Access Compliance Report

Public Rights-of-Way (Curb Ramps)

Intersection ID: 10020407	Main Street: BALLANTYNE_MEADOWS_DR	Cross Street: N/A	Location:	E
ADA ID: 6316F98A0C2C	Ramp Type: Perp	Initial Pass/Fail: Fail	Overall Compliance: No	Severity Score: 50
Codes/Mitigation Info/Possible Solution		Field Measurements/Component Compliance

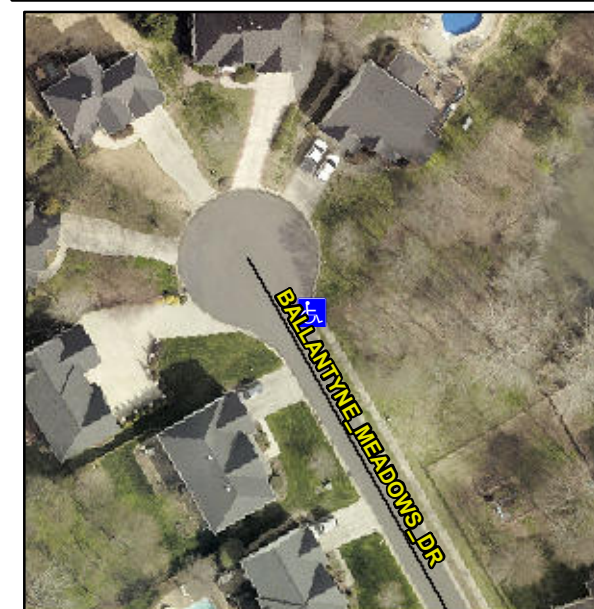
R304.2.2, R304.5.3

Compliance	Description	Data	Compliance	Description	Data
N/A	Ramp Length (in)	45.0	No	Ramp Slope (%)	19.5
Yes	Ramp Width (in)	48.0	No	Ramp XSlope (%)	14.9
N/A	Flare Type LT	N/A	N/A	Flare Type RT	N/A
N/A	Flare Slope LT (%)	N/A	N/A	Flare Slope RT (%)	N/A
N/A	Flare Traversable LT?	N/A	N/A	Flare Traversable RT?	N/A
N/A	Landing Length (in)	N/A	N/A	DWS Provided?	N/A
N/A	Landing Width (in)	N/A	N/A	DWS Contrast?	N/A
N/A	Landing Slope (%)	N/A	N/A	DWS Length (in)	N/A
N/A	Landing X Slope (%)	N/A	N/A	DWS Full Width?	N/A
N/A	Landing Curb? (Y/N)	N/A	N/A	DWS Offset (in)	N/A
N/A	Shared Landing?	N/A			
N/A	Gutter Ponding?	N/A	N/A	Gutter Slope (%)	N/A
N/A	Gutter Lip Ht (in)	N/A	N/A	Gutter X Slope (%)	N/A
N/A	Painted X Walk1?	No	N/A	Painted X Walk2?	N/A
	X Walk 1 Direction	To NW		X Walk 2 Direction	N/A
N/A	X Walk 1 Width (in)	N/A	N/A	X Walk 2 Width (in)	N/A
	X Walk 1 Slope (%)	2.0		X Walk 2 Slope (%)	N/A
	X Walk 1 X Slope (%)	2.1		X Walk 2 X Slope (%)	N/A

Remove & Replace Entire Ramp.
